OpenTX Documentation: Corrections and 2.1.9 Updates

September 2016

This document lists the errors found so far, one or two additions to the documentation and provides an update for new items in 2.1.9

OpenTX 2.1.9

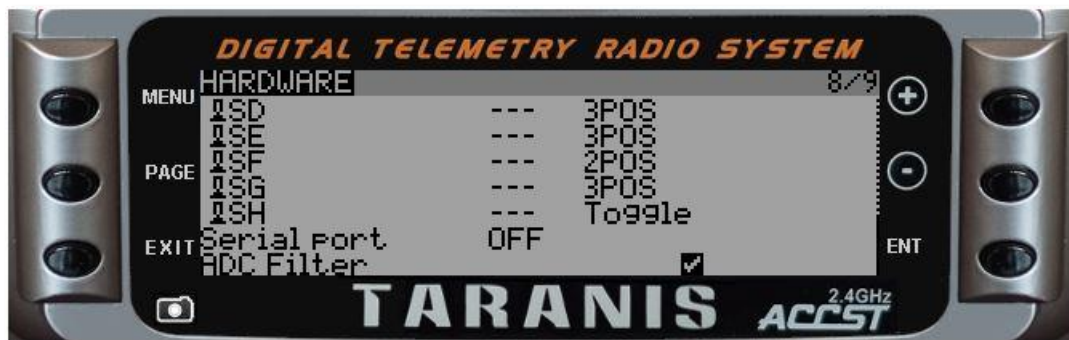
2.2.9 mainly fixes a few bugs, however there is one new option available. This is to turn off or on the jitter filter. This is on screen 8 of the Radio Setup screens. Note that improvements have also been made to this filter to reduce the jitter.
